## Report to Planning and Environment Committee

**Subject:** 489 Upper Queen Street  
Public Participation Meeting  
City File No: Z-9540 Ward 12

**Date:** January 30, 2023

**Figure 3: Revised Site Plan (Second/Final Submission)**

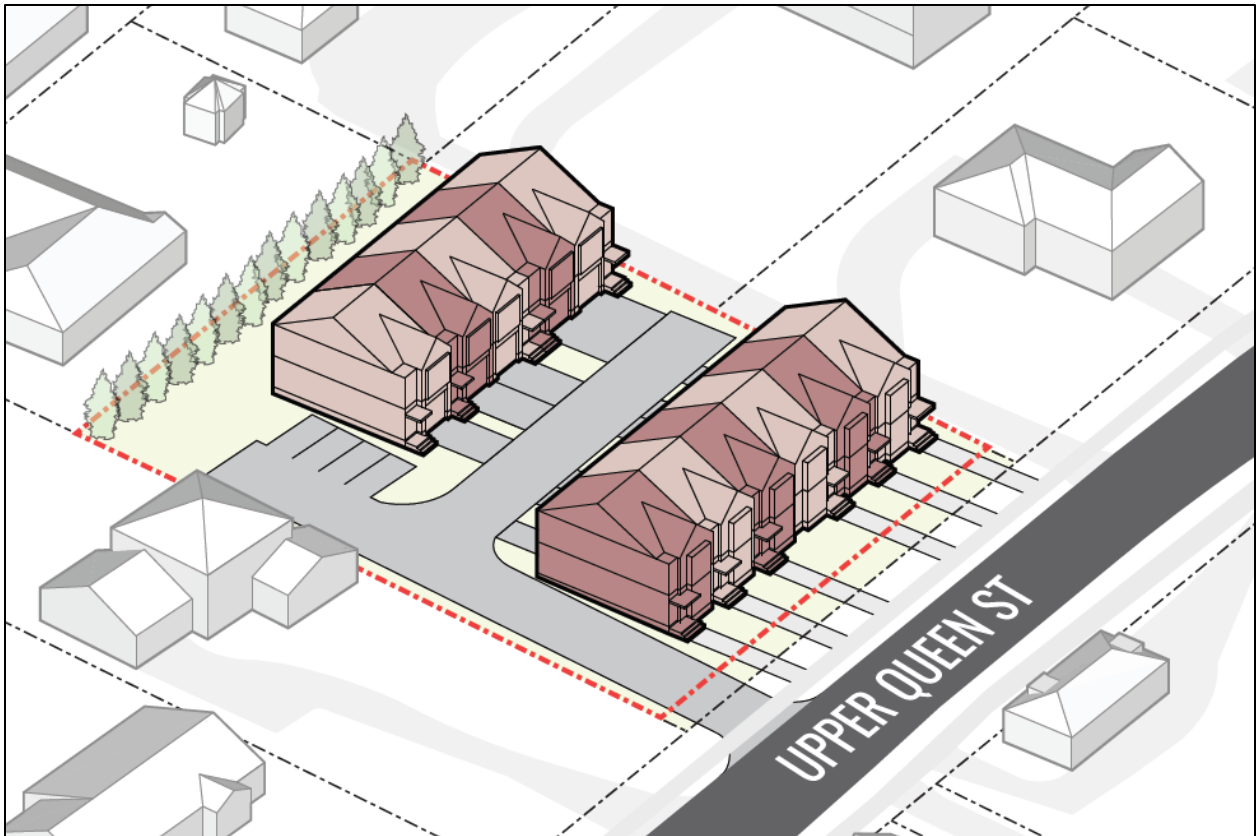
In response to Planning and Development, Site Plan, and Urban Design staff comments, the Applicant submitted a revised site concept plan to staff illustrating the following changes to the proposed site design:

<b>First Submission (November 21, 2022)</b>	<b>Second Submission (December 19, 2022)</b>
<ul style="list-style-type: none"> <li>• 11 townhouse units (5 in the rear and 6 oriented towards Upper Queen Street)</li> </ul>	<ul style="list-style-type: none"> <li>• 10 townhouse units (5 in the rear and 5 oriented towards Upper Queen Street)</li> </ul>
<ul style="list-style-type: none"> <li>• No dedicated pedestrian walkway from Upper Queen Street through the site.</li> </ul>	<ul style="list-style-type: none"> <li>• Removal of the southerly most unit in the front row has allowed for a dedicated pedestrian walkway through the site</li> </ul>
<ul style="list-style-type: none"> <li>• Lack of front yard amenity space for the western row of units – over pavement of front yards</li> </ul>	<ul style="list-style-type: none"> <li>• Reduction of garages and driveways for the western row of units to 3.0m to allow more landscaped space has been reflected in the special provisions at the end of this report.</li> </ul>

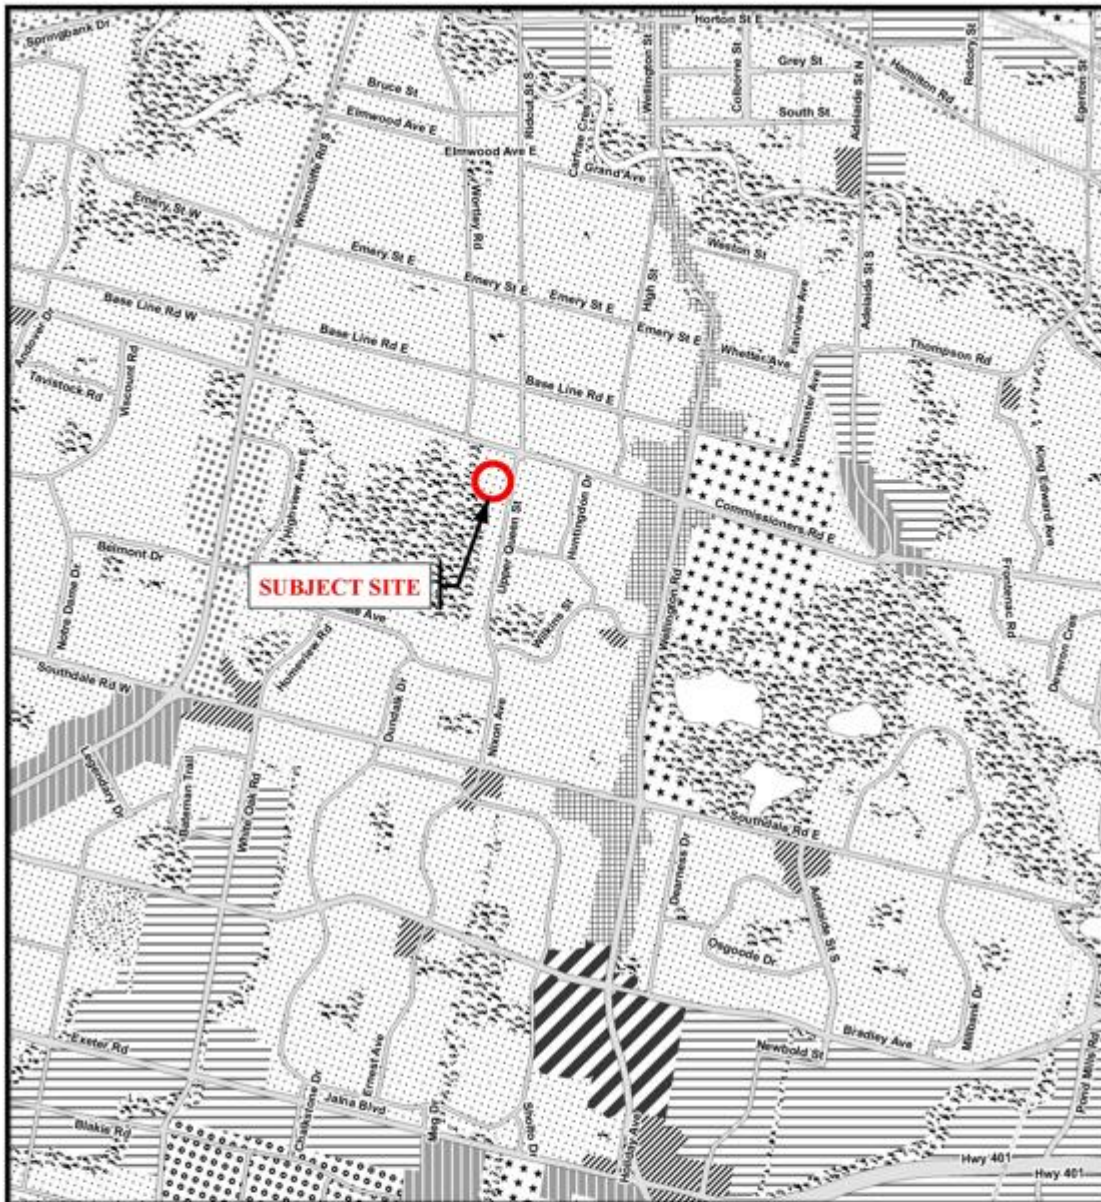
Please see below for UD comments related to the planning application at **489 Upper Queen St**. Many of these comments were provided at SPC but were not addressed through this process.

- Provide a pedestrian connection from the city sidewalk to the front entrances of the rear units as well as the common amenity space.
- Remove a unit from each of the townhouse blocks to allow for the pedestrian connection and a buffer between the drive aisle/parking area and the townhouse building edges.

- Reduce the driveway and garage widths for the rear units to not exceed 50% of the unit façade width.
- The applicant is to submit a completed “Urban Design Peer Review Panel Comments – Applicant Response” form that will be forwarded following the UDPRP meeting scheduled for September 2022. This completed form will be required to be submitted as part of a complete application.
